Response to DSD's comments (MKT37)

Proposed Temporary Warehouse for Storage of Food Provisions for a Period of 3 Years and Filling of Land at Lot 478 S.A RP, 482 (Part), 484 & 487 (Part) in D.D. 90, Lin Ma Hang Road, Ta Kwu Ling, NT

Figure 4

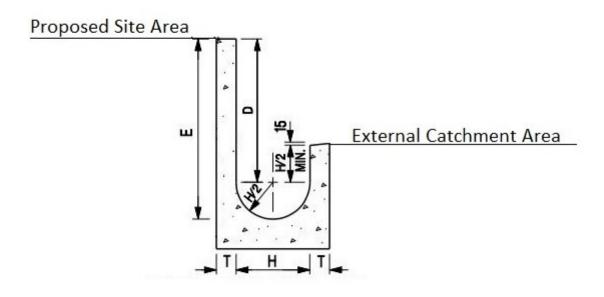
(e) Please elaborate how the overland flow from the external catchment can be collected by the proposed U channel with consideration of ground level after the proposed development. The applicant is reminded that all existing flow paths as well as the run-off falling into and passing through the site should be intercepted and disposed of via proper discharge points. The applicant shall also ensure that no works, including any site formation works, shall be carried out as may adversely interfere with the free flow condition of the existing drains, channels and watercourses on or in the vicinity of the subject site any time during or after the works.	Please see the enclosed Figure 3 and 4.

(h) The applicant is reminded that where walls are erected or kerbs are laid along the boundary of the same, peripheral channels should be provided on both sides of the wall or kerbs, and/or adequate openings should be provided at the walls/kerbs to allow existing overland flow passing through the site to be intercepted by the drainage system of the site with details to be agreed by DSD, unless justified not necessary.	Noted, please see the enclosed Figure 4.
